Technical product information

Topic	Mulsanne Radiator Grille Finisher Adrift
Market area	Bentley: worldwide (2WBE),Hongkong-Macau (5HK)
Brand	Bentley
Transaction No.	2042177/1
Level	EH
Status	Approval
Release date

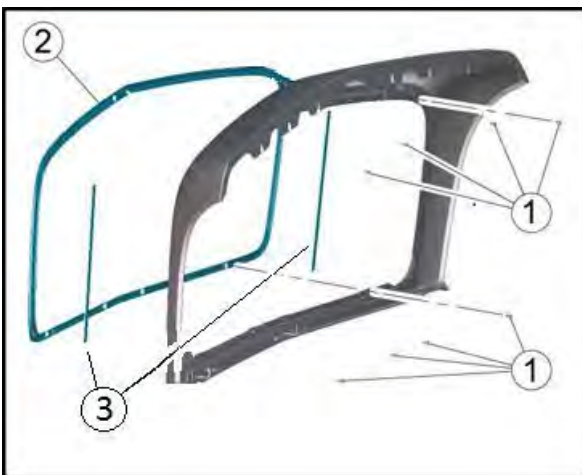
The adhesive attaching the Radiator Grille Finisher to the Mounting Blocks, may in some instances fail, causing the Radiator Grille Finisher to become detached at one or more mounting locations.

Radiator Grille Finisher Mounting Block adhesive is replaced by soft soldering

On complaint of a Radiator Grille Finisher being detached at one or more mounting locations, verify the cause to be Mounting Block adhesive failure, if so, the Radiator Grille Finisher should be replaced with Part Number 3Y0.853.667.C.

It may be necessary to replace the Foam Inserts 3W8.868.283.A if they are found to be damaged

Item	Description
1	Mounting block screw locations
2	Radiator Grille Finisher
3	Foam Inserts
